MAINTENANCE INSTRUCTION

MODIFICATION RECOMMENDATION

IMPROVED GROUND FAULT DETECTION SYSTEM

Fig.1 - Ground Relay Circuit On Early AR10 Locomotives

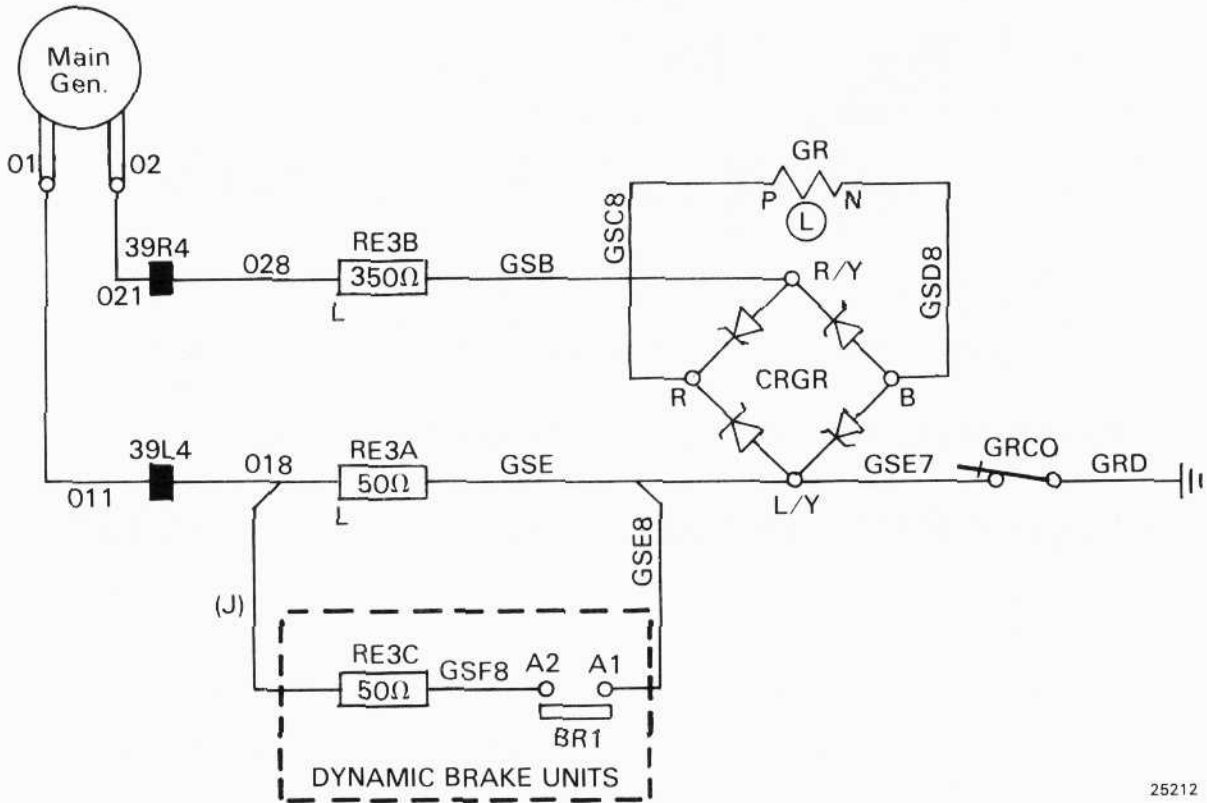
The original ground relay circuit, as applied to early AR10 equipped locomotives is shown in Fig. 1. This circuit was the subject of a field modification in 1967, and there should be very few of these systems currently in service. If this circuit should be found on an existing locomotive, the basic procedure in this M.I. can be followed, except that new wiring must be extended to the 01 and 02 neutral leads in the AR10 airbox, GS11 must be spliced with GS12, and GN11 must be spliced with GN12. Contact your field representative for assistance.

Fig.2(a) - Possible Original Circuit

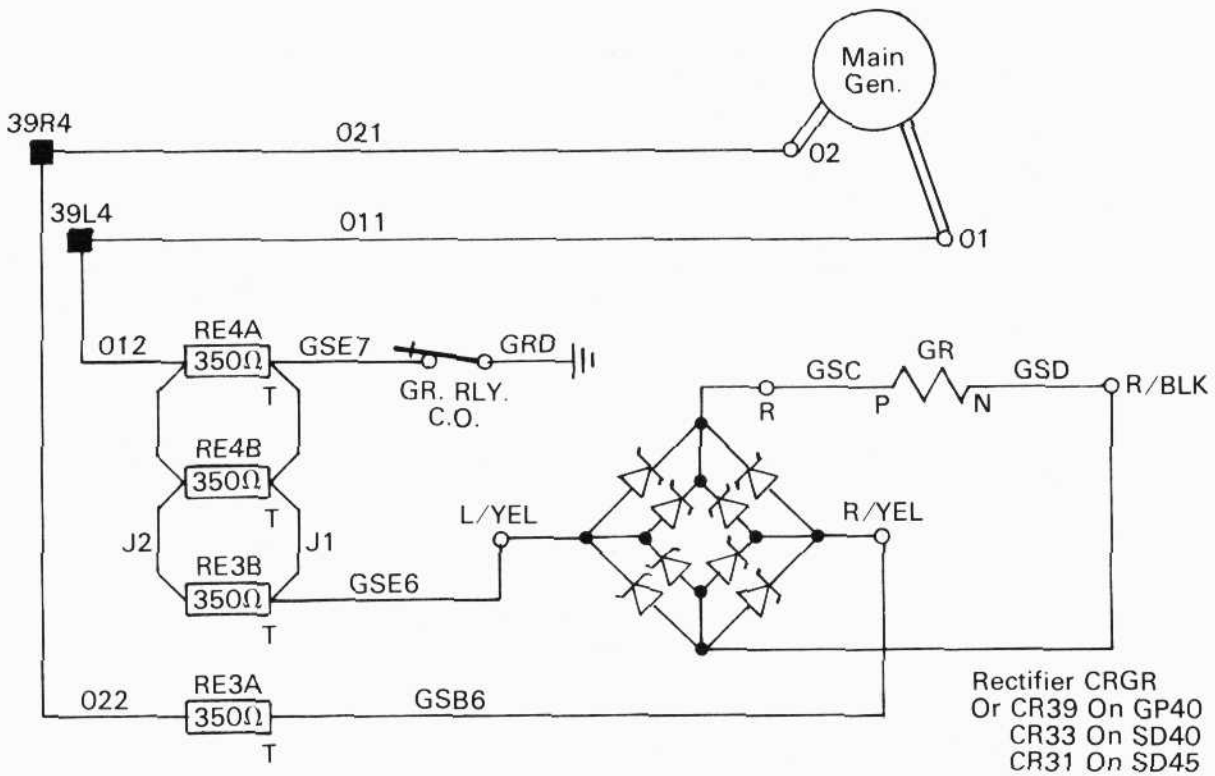
The circuit shown in Fig. 2 (a) (or a variation) should be in most locomotives. A previous circuit which appeared on all GP40, SD40 and SD45 locomotives built prior to July 1, 1967, is shown in Fig. 2 (b). The modification of the circuit shown in Fig. 2 (b) to that in Fig. 2 (a) was covered in M.I. 9557.

All instructions in this M.I. are referenced to the circuit in Fig. 2(a). Some differences in wire names may exist between this diagram and wiring existing on a particular locomotive. Therefore, instructions should be checked against the actual locomotive schematics. The final desired circuit is shown in Fig. 3.

Fig.4(b) - Modified Ground Relay Detection Circuit For Head End Power Equipped Units

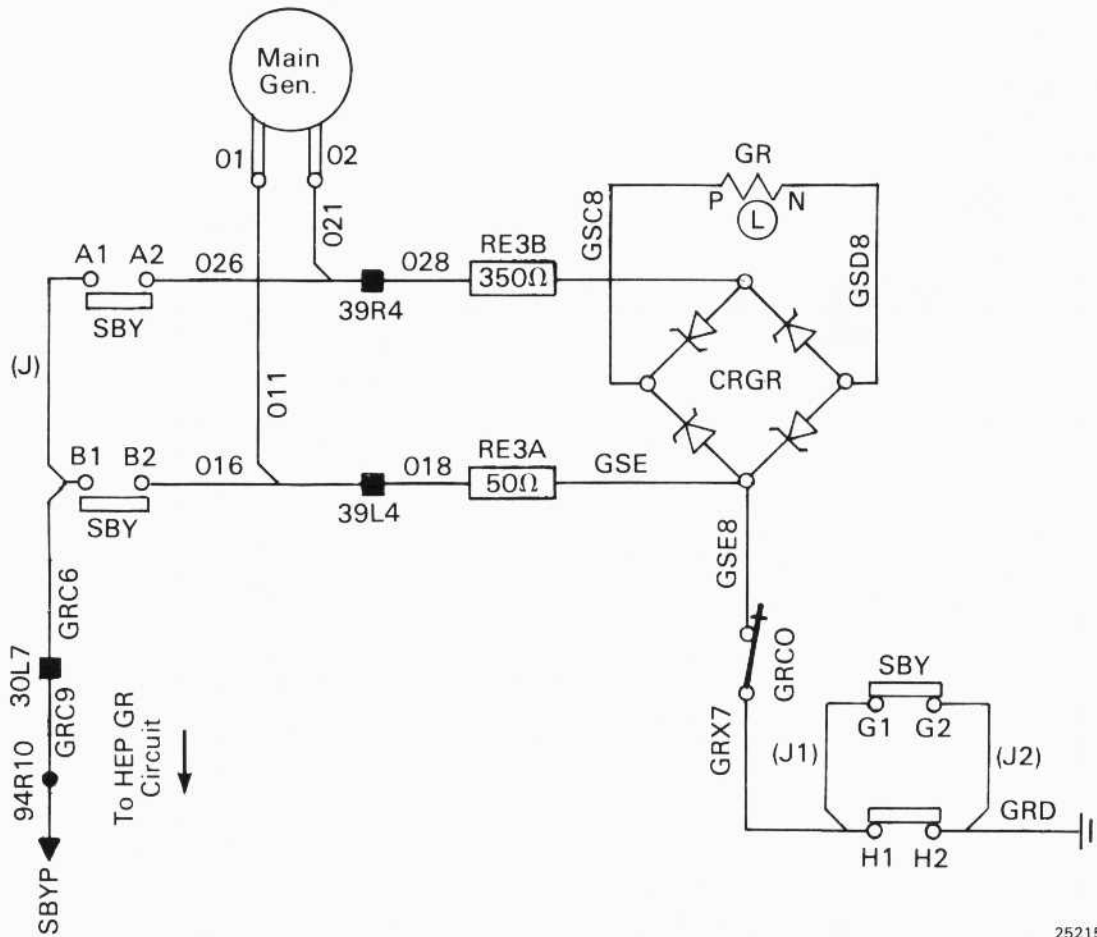
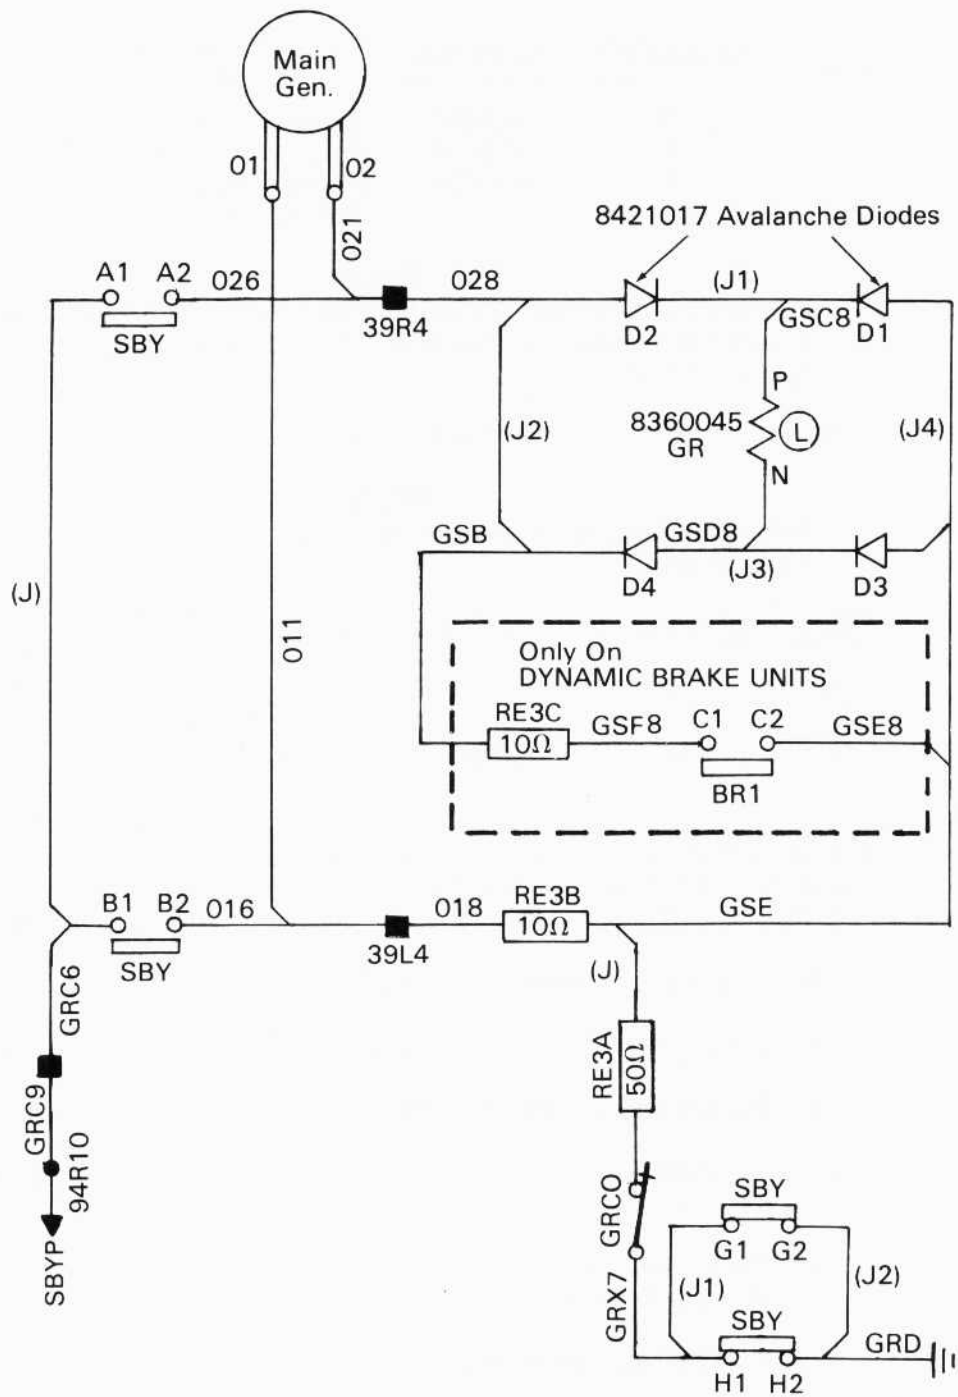
Locomotives equipped with head end power (F40PH) also have an adjoining H.E.P. ground detection circuit as shown in Fig. 4 (a). The wiring to the H.E.P. ground detection circuit should not be disturbed, resulting in the circuit shown in Fig. 4 (b).
